802.3dj D2.0

Comment Resolution

Electrical Track

Figure 178-2—200GBASE-KR1, 400GBASE-KR2, 800GBASE-KR4, or 1.6TBASE-KR8 link

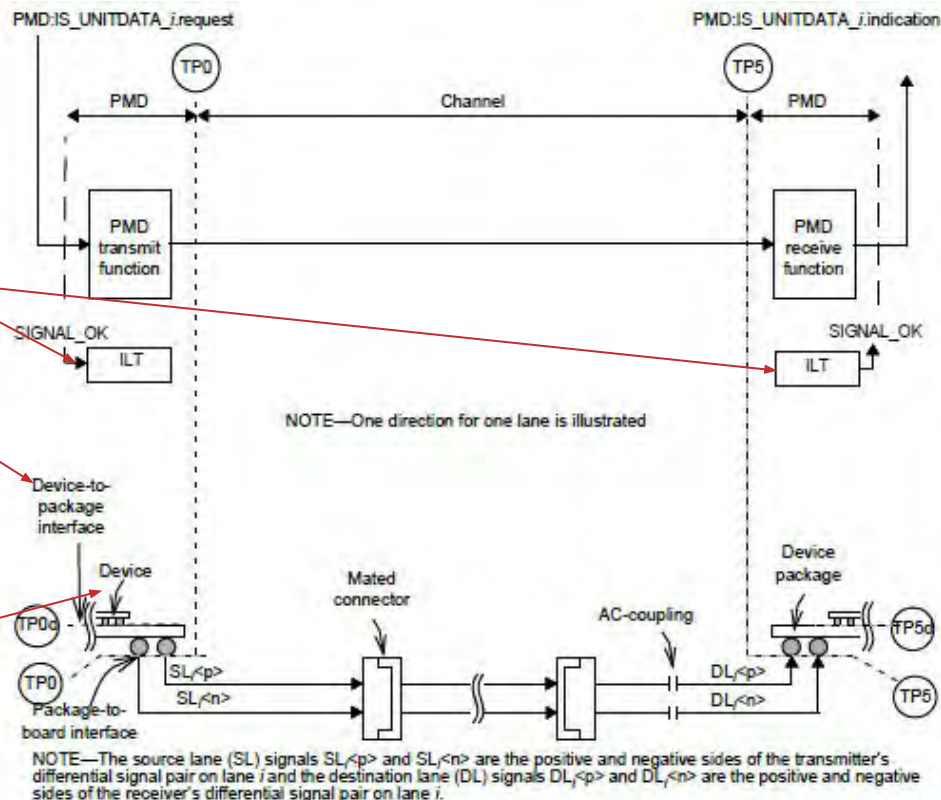
In Figure 178-2 add the ILT function above the PMD transmit and receive functions. Show the SIGNAL_OK as an input to the ILT function at the left side and as an output to the ILT function in the right side (refer for example to Figure 180-2)

Figure 178-2. The interface at TP0 is helpfully labelled as "package-to-board interface". A similar label would be helpful at TP0d.

In Figure 178-2, make the following changes:

Show the PMD ending and "channel" beginning at TP0 and TP5.

Add a label at TP0 and TP5 "MDI".

Change label pointing to the die on the left side of the Figure 178-2 to "Die".

- 92: Add the ILT function & SIGNAL_OK above PMD function.
- 302: ~~Label “Die to package interface at TP0d. Also apply to Figure 176C 2.”~~
- 303: Show channel going from TP0 to TP5. Add “MDI” at TP0 & TP5. (and in Figure 176C-2)
- 304: ~~Change label on die at left from ‘device’ to ‘die’.~~
- 640: Change subclause title to “Reference test points”.

Editor's recommendations: Implement the changes listed on this slide (not including the change of “device” to “die”).

Figure 178-3—Transmitter test fixture and test points

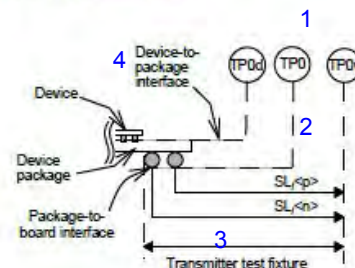
Figure 178-3. It is ambiguous where the test fixture begins. The intent is that the text fixture begins at TP0. Also, it would be good to properly describe the TP0d interface. This figure nor the text definitely define the start and end points of the test fixture.

In Figure 178-3 do the following:

Add test point TP0 at the "package-to-board interface". 1

Add a label at the TP0d interface "die-to-package interface". 4

Updated figures and text.

Unless otherwise noted, measurements of the transmitter are made at the output of a test fixture (TP0v) as shown in Figure 178-3 and described in Annex 163A. The transmitter test fixture is between TP0 and TP0v. An example test fixture is described in Annex 163B.

176D.8.2 Effective return loss (ERL)

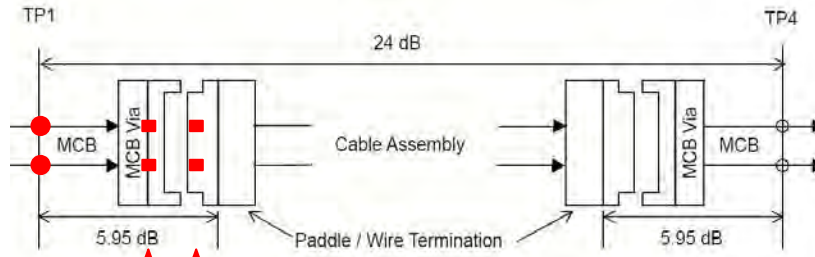
CI 176D	SC 176D.8.2	P 752	L 29	# 361
Ghiassi, Ali Ghiasi Qunatum/Marvell				
Comment Type	TR	Comment Status	D	(Electrical) Tfx
Line 30 says that "Tfx equal to twice the test fixture delay", statement is not clear.				
Suggested Remedy				
Tfx for measurement of Host Input/Output is twice the HCB delay. Tfx for measurement of Module Input/Output is twice the MCB delay. Suggest to move Tfx into the table and make the above as footnotes in the table. We shouldn't state in IEEE standard "Tfx is provided by the test fixture provider", what about if fixture supplier doesn't?				
Proposed Response Response Status W				
PROPOSED REJECT. The test fixture delay is defined in detail in the second paragraph of 176D.8.2 for both host and module measurements. Based on these definitions, the statement should be clear. The suggested remedy does not match the second paragraph and would not improve clarity. The statement that "Tfx is provided by the test fixture provider" was added by the response to comment #199 against D1.1, see < https://www.ieee802.org/3/dj/comments/D1p1/8023dj_D1p1_comments_final_clause.pdf#page=77 >. It should be understood as a requirement. The suggested remedy does not provide an alternative phrasing for this statement.

This comment is specifically about the span of Tfx in a cable assembly test fixture (aka MCB).

Figure 176D-5—Module compliance points

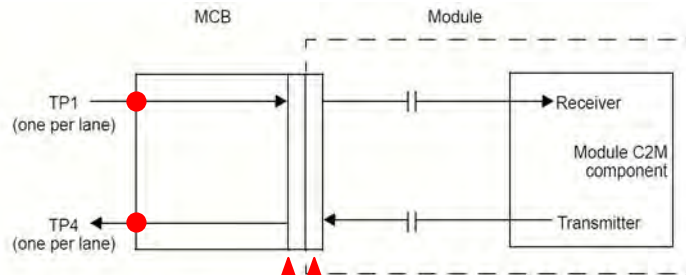
- A: MCB connector pads
- B: Receptacle mating point (Cable/HCB pads/Gold Fingers)
- C: Somewhere else?

Discussion points:

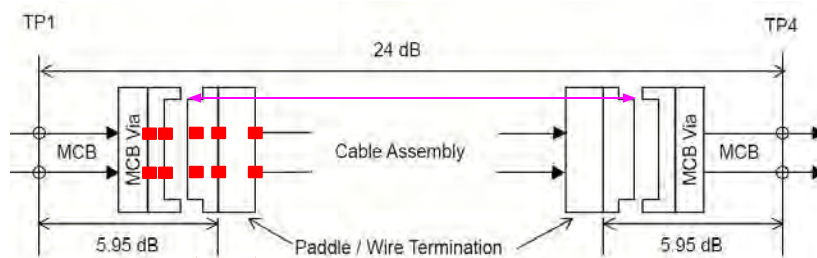
CI 176D	SC 176D.8.2	P 752	L 29	# 361
Ghiasi, Ali Ghiasi Qunatum/Marvell				
Comment Type	TR	Comment Status	D	(Electrical) Tfx
Line 30 says that "Tfx equal to twice the test fixture delay", statement is not clear.

Suggested Remedy				
Tfx for measurement of Host Input/Output is twice the HCB delay. Tfx for measurement of Module Input/Output is twice the MCB delay. Suggest to move Tfx into the table and make the above as footnotes in the table. We shouldn't state in IEEE standard "Tfx is provided by the test fixture provider", what about if fixture supplier doesn't?				
Proposed Response Response Status W				
PROPOSED REJECT. The test fixture delay is defined in detail in the second paragraph of 176D.8.2 for both host and module measurements. Based on these definitions, the statement should be clear. The suggested remedy does not match the second paragraph and would not improve clarity. The statement that Tfx is provided by the test fixture provider" was added by the response to comment #199 against D1.1, see < https://www.ieee802.org/3/dj/comments/D1p1/8023dj_D1p1_comments_final_clause.pdf#page=77 >. It should be understood as a requirement. The suggested remedy does not provide an alternative phrasing for this statement.

In 176D.8.2 change from:

"For module input and output ERL, the test fixture delay is defined as the propagation delay between the test connector and the module-facing connection, excluding the mating interface discontinuity."

"For module input and output ERL, the test fixture delay is defined as the propagation delay between the test fixture's coaxial connector and the discontinuity of the MDI connector".

Change other instances of "test connector" to "test fixture's coaxial connector".

CR Test Fixture

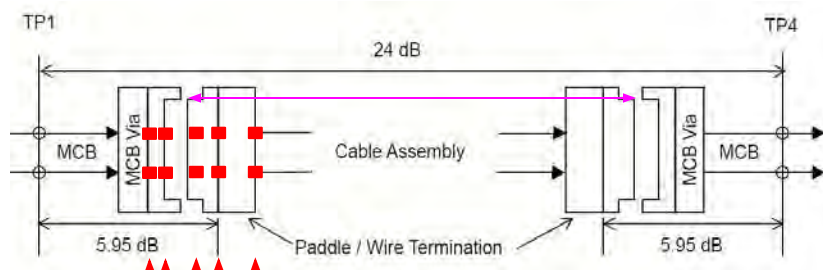
- Is the text “Paddle / Wire Termination” in the Figure clear, and useful?

CI 179A	SC 179A.5	P 821	L 4	# 658
Swenson, Norman	Nokia, Point2			
Comment Type	TR	Comment Status	D	(Electrical) CR test fixture
What is the extra rectangle labeled Paddle/Wire Termination shown in Fig. 179A-2 that is not shown in the mated test fixtures in Fig 179A-1? It is not explained in the text.				
Suggested Remedy				
Clarify				
Proposed Response

Response Status W				
PROPOSED ACCEPT IN PRINCIPLE.				
The rectangle and labels "Paddle/Wire Termination" serve as demarcation of the cable assembly and the host channel, in Figures 179A-1, 2, and 3. The "Paddle" and "Wire Termination" are structures associated with the cable assembly, and are not necessarily present in an HCB (or Mated Test Fixture). The labels are used to identify specific structures that are not documented elsewhere in the figure.				
These figures provide illustration as appropriate within an informative Annex. Similar figures with the same features are included in in Annex 162A, added by IEEE Std 802.3ck.				
The suggested remedy does not contain sufficient detail for the CRG to discuss a specific change.

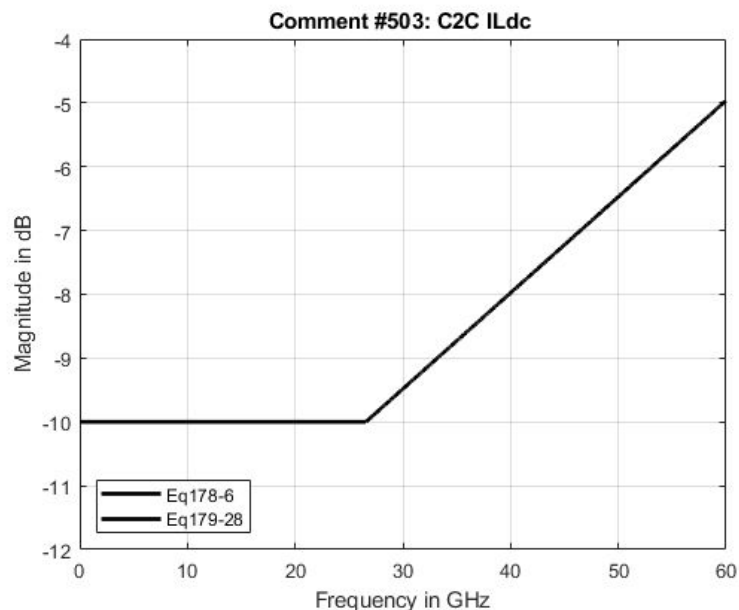
CI 176C	SC 176C.7	P 731	L 17	# 503
Dudek, Mike		Marvell		
Comment Type	TR	Comment Status	D	(Electrical) C2C channel

Add a specification to the channel specification for differential-mode to common-mode conversion with the same equation as used for KR (equation 178-6) or as used for CR cable (equation 179-28)

The comment addresses an inconsistency in the specifications. ILcd and ILdc are specified for the KR channel but not for the C2C channel.

In Table 176C-6, add rows for ILcd and ILdc referring to the same equations as in Table 178-11.

Implement with editorial license.

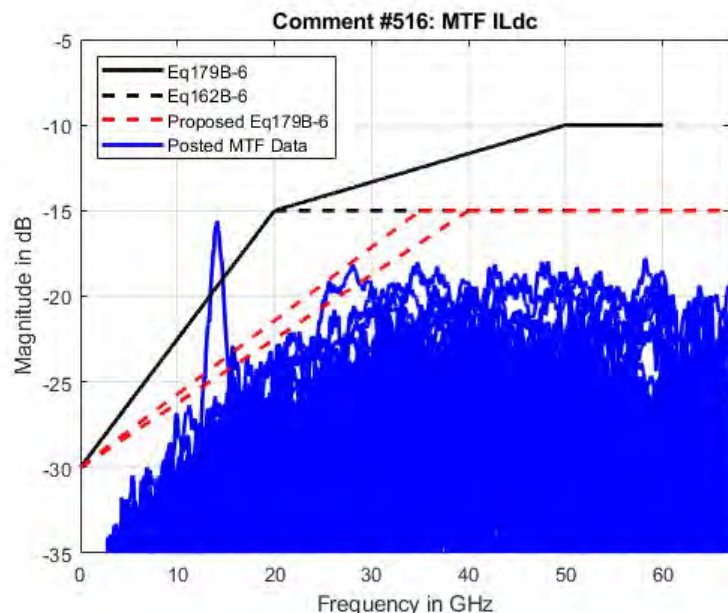
Cl 179B	SC 179B.4.3	P 826	L 44	# 516
Dudek, Mike		Marvell		
Comment Type	TR	Comment Status	D	(Electrical) MTF - ILdc
<p>There isn't a specification for the differential-mode to common mode insertion loss but theoretically it will be similar to the common mode to differential insertion loss. The specification in section 179B.4.3 is very weak and an MCB that only just passes this specification would cause a module to fail the 60mV full band AC common-mode specification in Table 176D-3 even if the module itself has no AC common mode output noise.</p>				
Suggested Remedy				
<p>Change Equation 179B-6 (and figure 179B-3) to $30-(21/28)*f$ from 0.01 to 40GHz and 15 from 40GHz to 67GHz which is the scaled equation from clause 162B.4.3</p>				
Proposed Response		Response Status	W	
<p>PROPOSED ACCEPT IN PRINCIPLE.</p> <p>The comment claims that the mask is too weak, and specifically that the Clause 179B mask should satisfy the Clause 162B mask at a minimum. The current mask is based on MTF measurements available as of D1P1, as shown in https://www.ieee802.org/3/dj/public/24_09/ran_3dj_01_2409.pdf#page=18. The proposed resolution may require more justification regarding the specification requirements in Table 176D-3.</p> <p>For CRG discussion.</p>
